FCO RA81X-I-013

FIELD CHANGE ORDER

Number: RA81X-I-013

HDA REPLACEMENT FCO

QUICK CHECK FOR RA81X-F-009

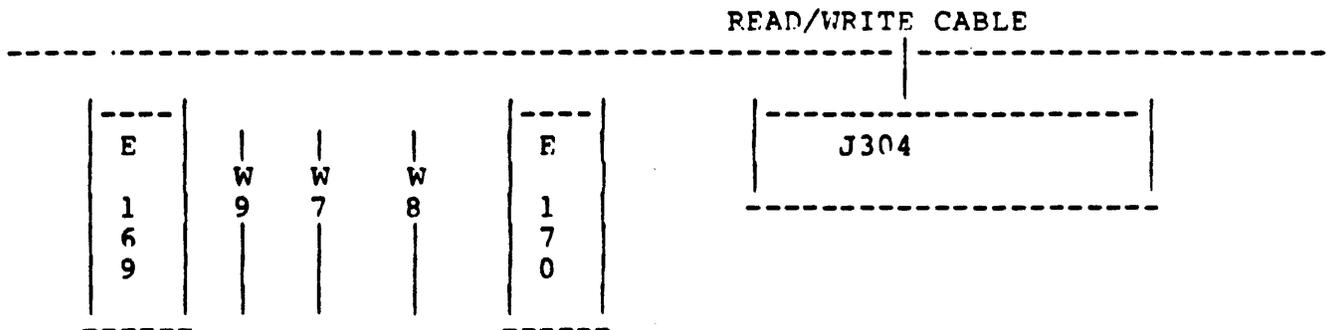
PRESENCE OF 0.1 UFD CAPACITOR AT LOCATION C29 AND 38.3 OHM PRECISION RESISTOR (ORANGE-GRAY-ORANGE) AT LOCATION R64. RA81X-S-004, R/W MODULE (54-15253) MUST BE AT CS REVISION LEVEL "D" BEFORE INSTALLATION OF THIS FCO. PROBLEM - HIGH RATE OF ERROR CODES 62 AND/OR 63. INTERMITTENT, UNEXPLAINED BURSTS OF ECC ERRORS.

Figure 6 PRELIMINARY

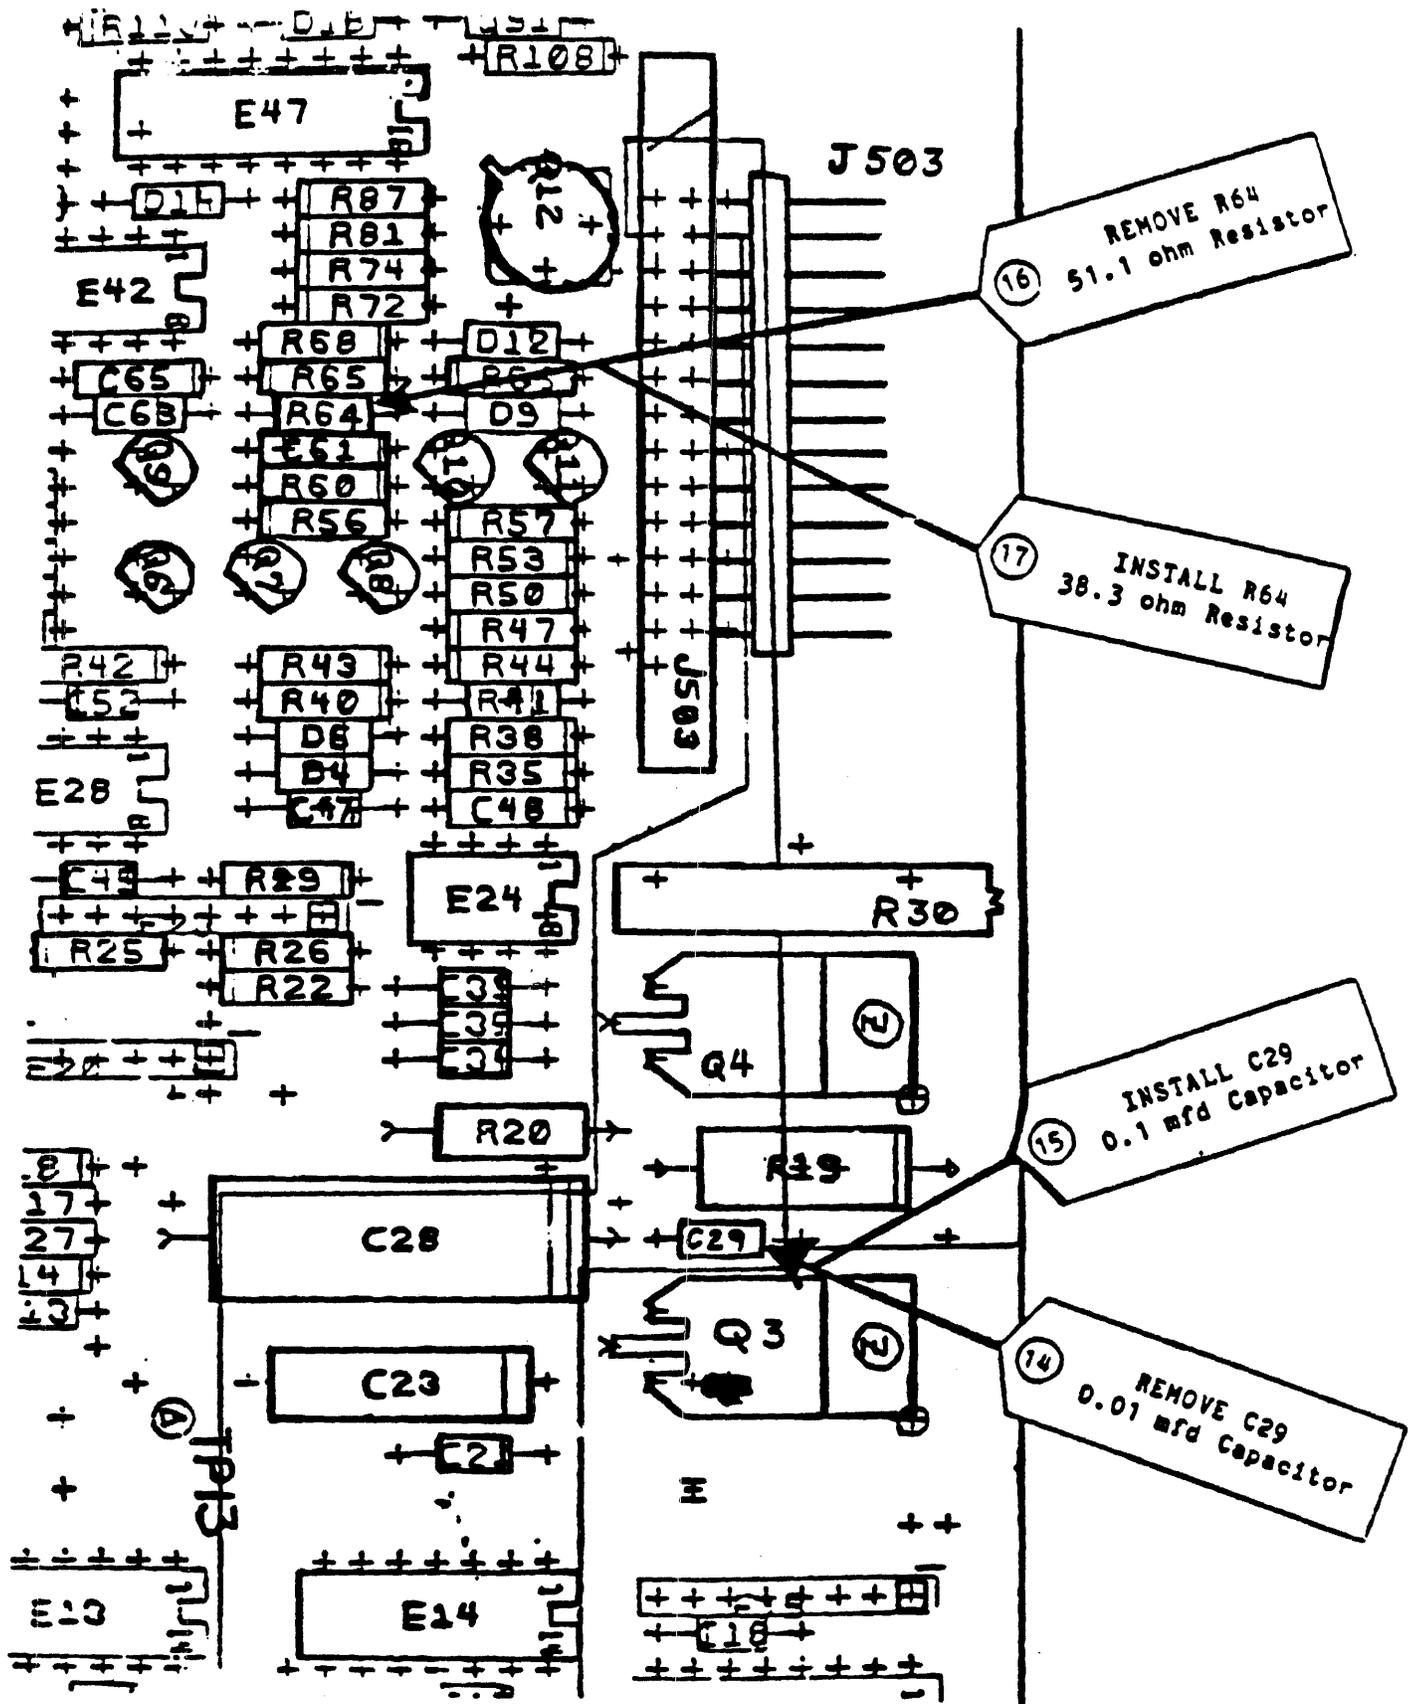
17. Remove R64 (51.1 ohms, 1/4 watt, 1%, resistor). Refer to Figure 6. This resistor may be identified by the marking "51R1" OR color-coded with the color bands "Green-Brown-Brown-Gold-Brown".
18. Install R64 (38.3 ohms, 1/4 watt, 1% resistor, p/n 13-05121-00) supplied in the FCO Kit. Refer to Figure 6. This resistor may be identified by the marking "38R3" OR color-coded with the color bands "Orange-Grey-Orange-Gold-Brown".
19. When the above rework is complete, mark the module "CS Revision F1".
20. Re-Install the reworked R/W module back into the drive.
21. Lower the drive chassis until the chassis latch engages.
22. If the drive is fixed mounted (top drive), proceed to rework step 25.
23. Push in on Slide Arm "B" and slowly slide the drive back into the cabinet. (Figure 3)

Figure 6
JUMPER LOCATIONS

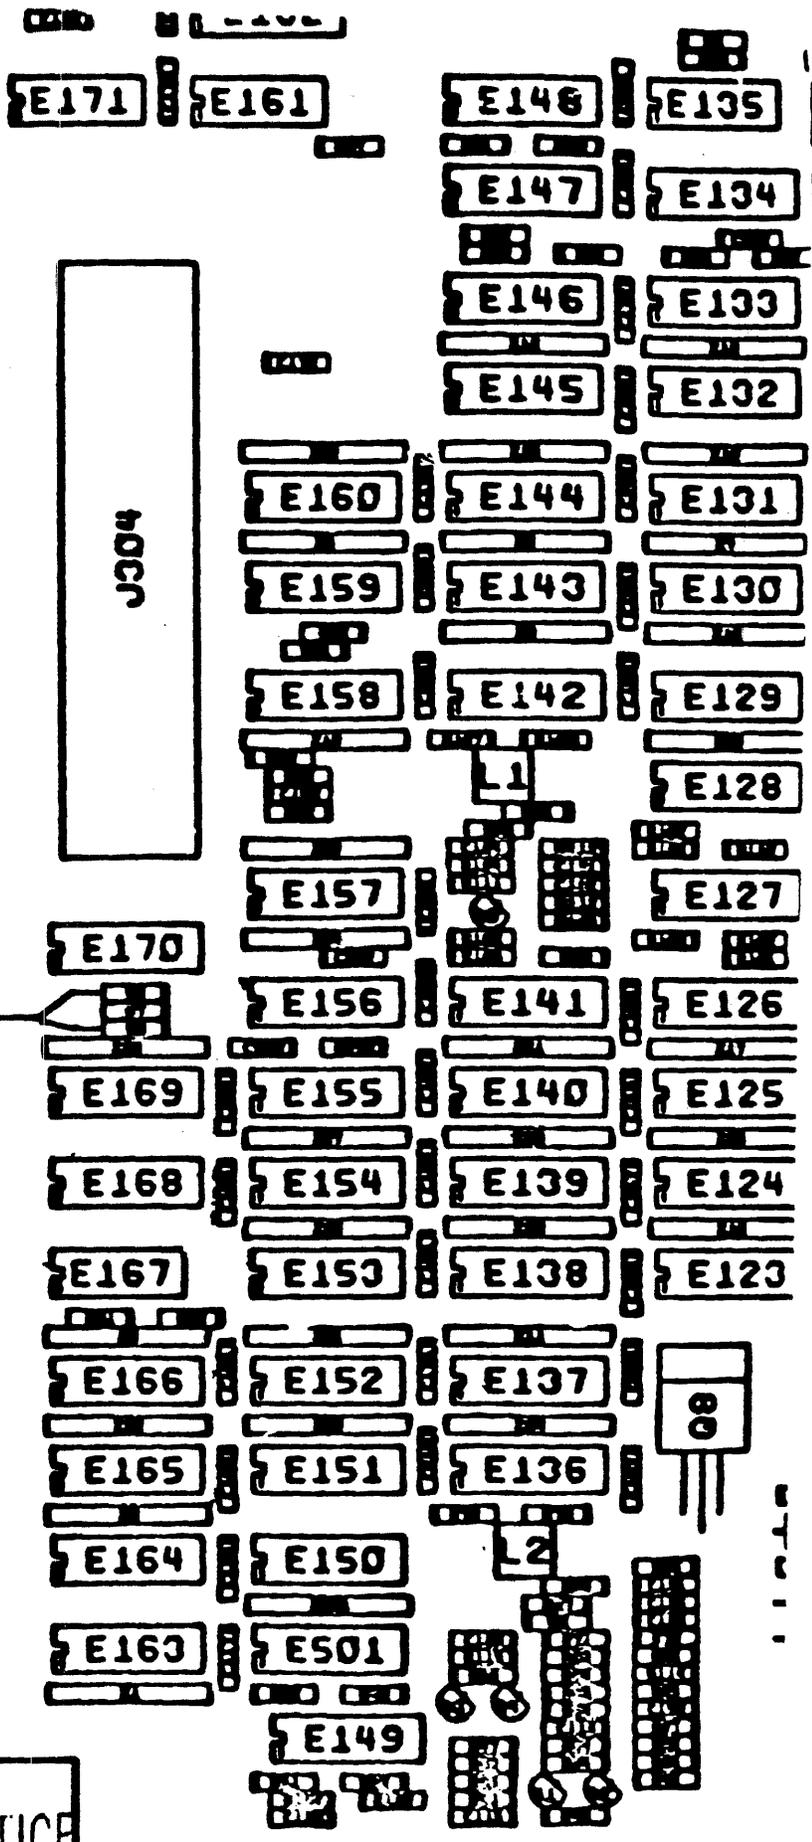
1. THE JUMPERS ARE LOCATED ON THE MICROPROCESSOR MODULE. (Figure 6)
2. FOR PROPER JUMPER POSITION, LOCATE W7, W8, and W9, see Figure 7.
3. VERIFY THE CURRENT JUMPER SELECTION

CURRENT SETTING	CHANGE	RESULT
W9, W8, W7 OUT	ADD W9	W9 IN
W9 IN / W7, W8 OUT	ADD W8	W8 W9 IN
W8 IN / W7, W9	ADD W7 AND W9 REMOVE W8	W7 W9 IN
W9 AND W8 IN / W7 OUT	ADD W7 REMOVE W8	W7 W9 IN

FIGURE 7

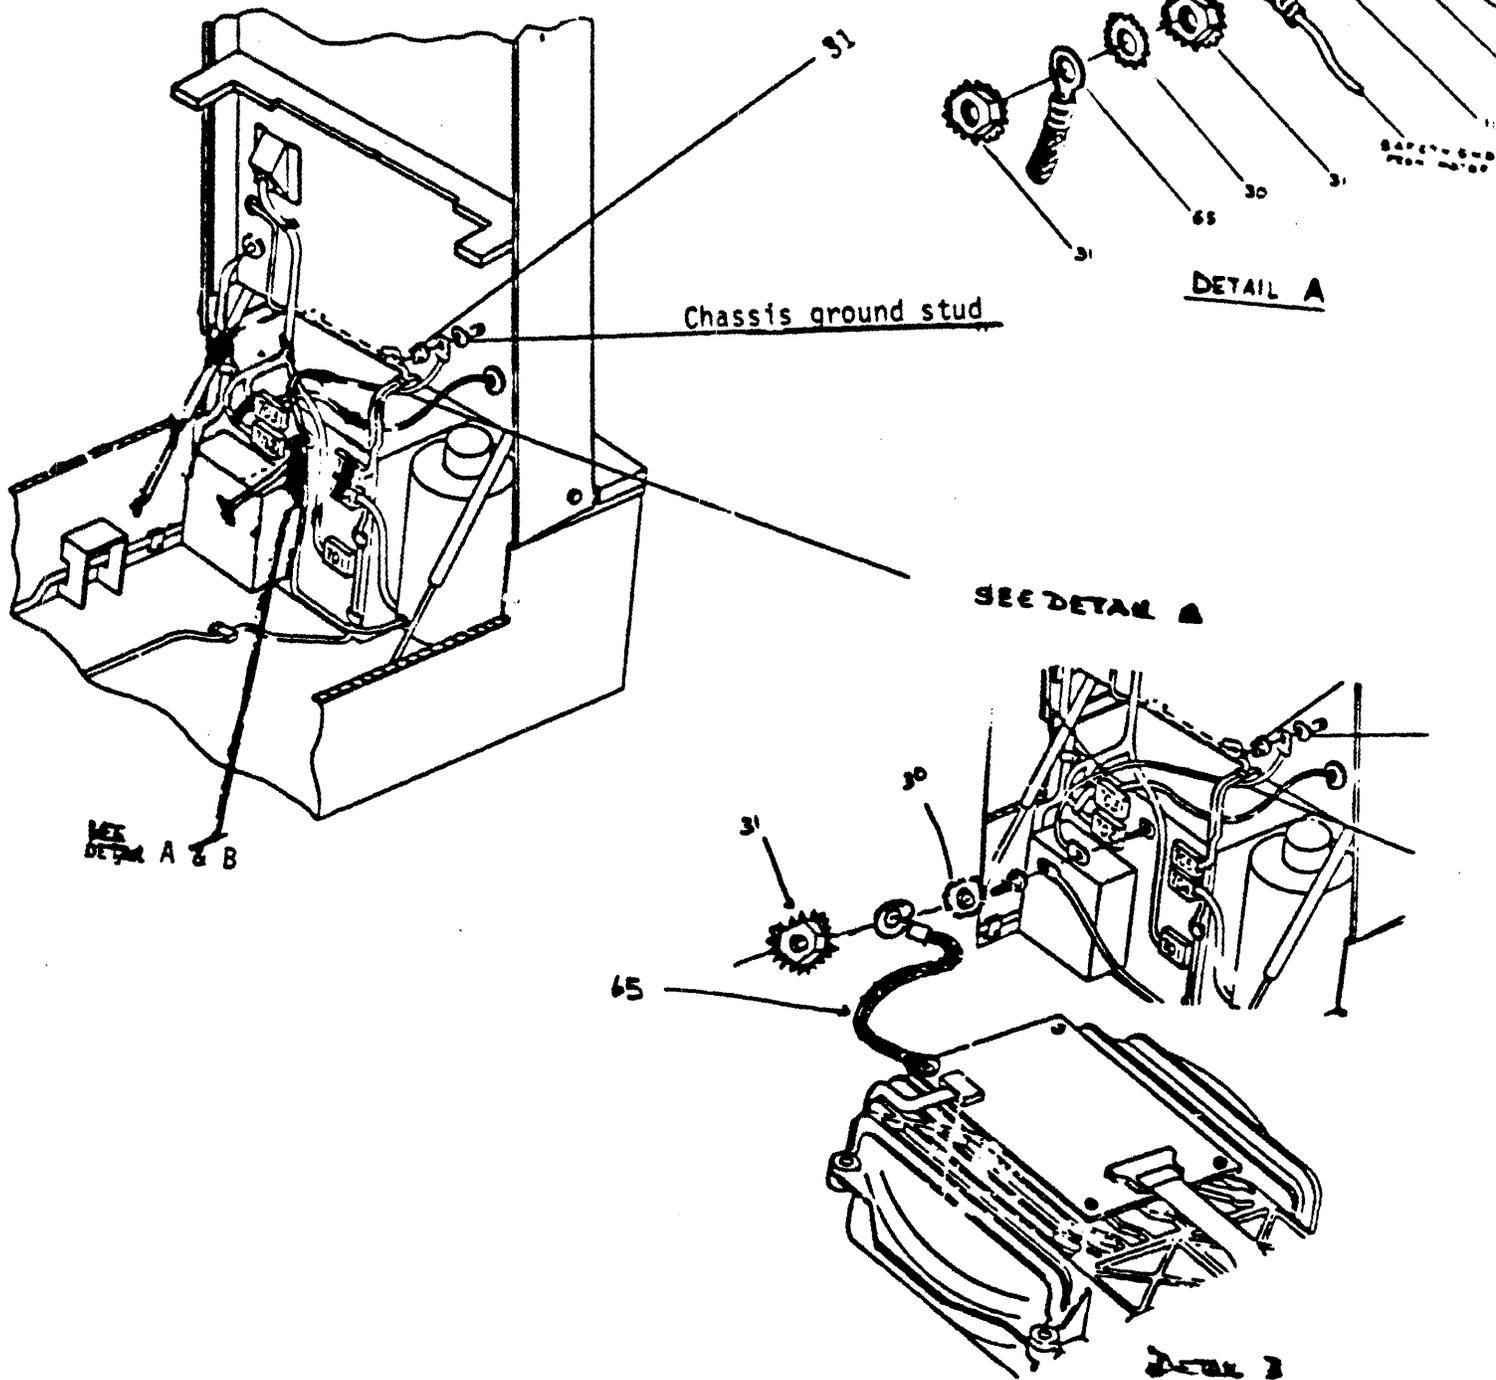
20. Attach the other end of the Ground Strap to the Power Supply ground stud using the Kept Nut and Star Washer supplied in the EQ Kit (SEE DETAIL A and B of FIGURE 7).

FIGURE 8

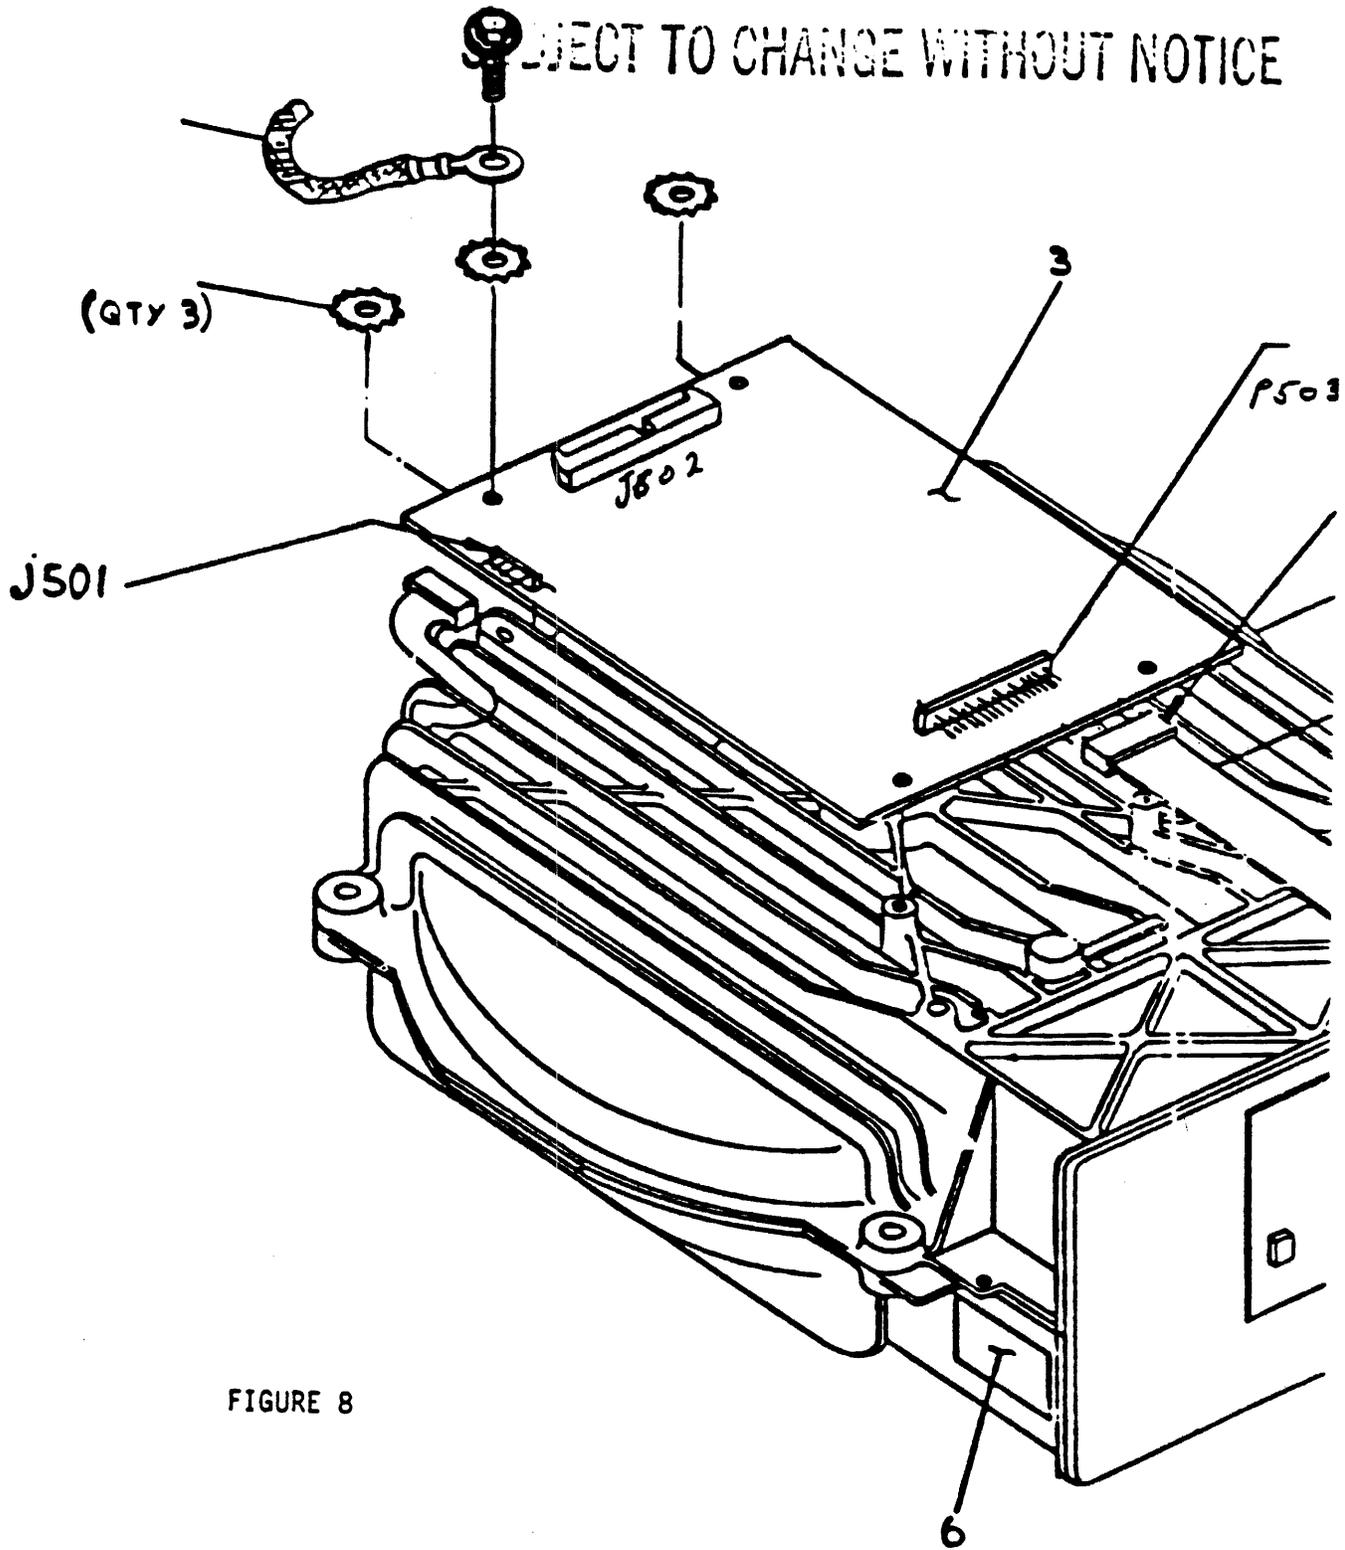
13. Remove all four (4) of the Read/Write Module (54-15253) hold down screws. Save the shorter screws and return to stock (FIGURE 8).
14. Lift the rear portion of the Read/Write module up to expose the HDA mounting standoff.

15. Place one Star Washer (90-08151-00) under the left and right mounting standoff (FIGURE 8).
16. Lay the Read/Write back in place, and attach the two front hold down screws using the Longer Screws (90-10075-01) supplied in the F.C.O. EQ Kit.

17. Insert the Longer Screw through one end of the HDA Ground Strap (12-25629-01) (FIGURE 8).
18. Place one Star Washer (90-08151-00) on top of the left rear Read/Write module grounding pad (FIGURE 8).

19. Attach Ground Strap, Longer Screw, and Star Washer to the left rear Read/Write module hold down. Insure that the lower Star Washer is still in place (FIGURE 8).

HARDWARE REVISION LEVEL SWITCHES FIGURE 9

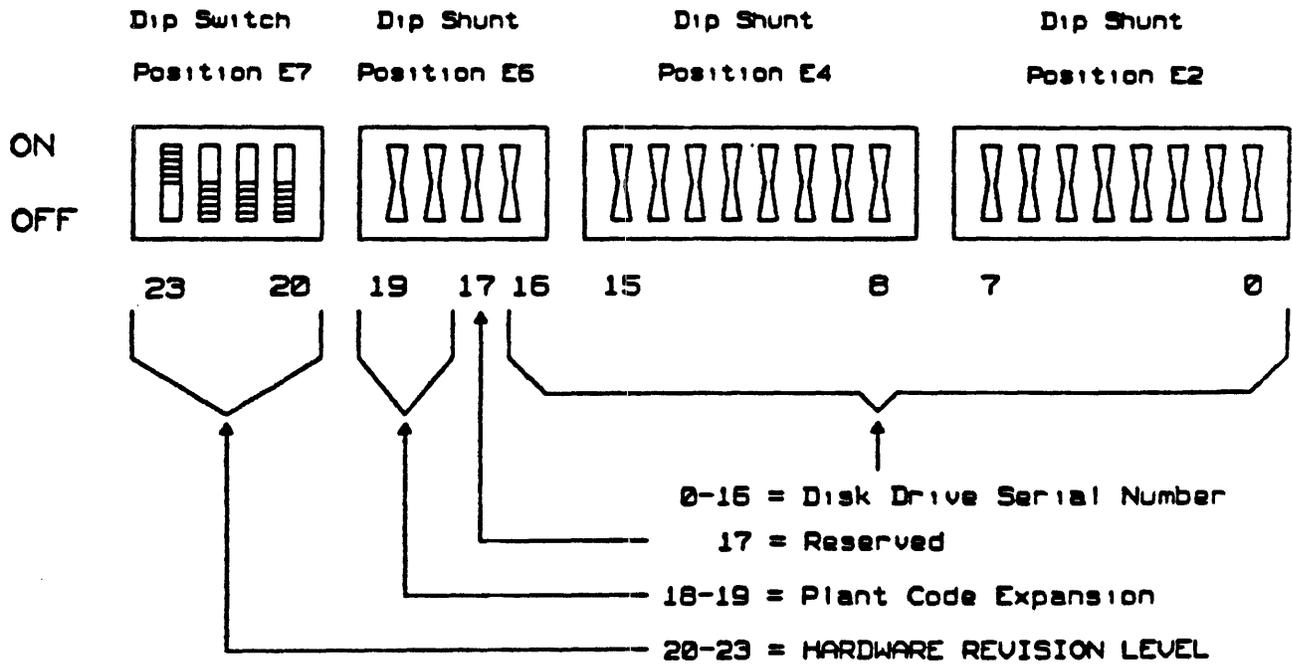
21. Close the logic chassis, DO NOT SLAM SHUT - HDA DAMAGE MAY OCCUR.
22. The Hardware Revision level switches are to be changed to seven (7). Remove the front bezel by removing the upper and lower mounting screws from each side of the drive (FIGURE 10).

23. Remove the Operator Control Panel from the Bezel (FIGURE 11) and change the switches to reflect a hexadecimal seven (7) (FIGURE 9).
24. Replace the front bezel cover.

Set the DIP SWITCHES for the Hardware Revision Level on the Operator Control Panel (54-14927) to the indicated positions:
